# Access Compliance Report

## Public Rights-of-Way

Intersection ID: 5833	Main Street: GUM_BRANCH_RD	Cross Street: KENTBERRY_DR	Location: W
ADA ID: 7447D6AFBE8D	Ramp Type: Directional1	Initial Pass/Fail: Pass	Overall Compliance: No
Severity Score: 2.5			
Codes/Mitigation Info/Possible Solution		Field Measurements/Component Compliance

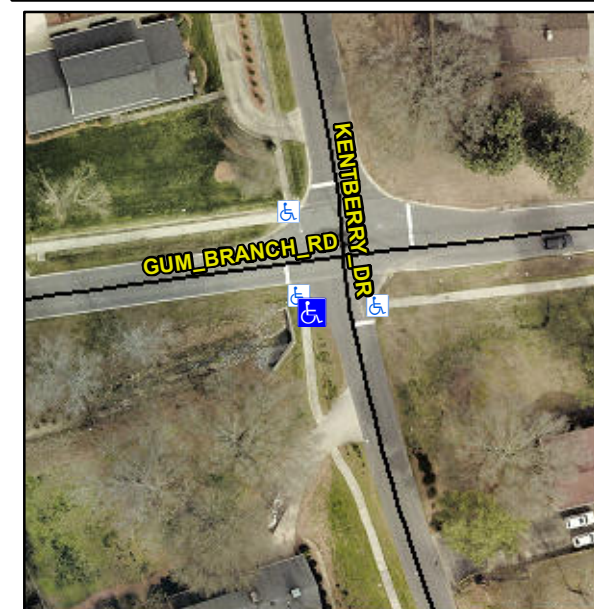
**R305.1.4, R305.2**

**Remove & Replace Detectable Warning System.**
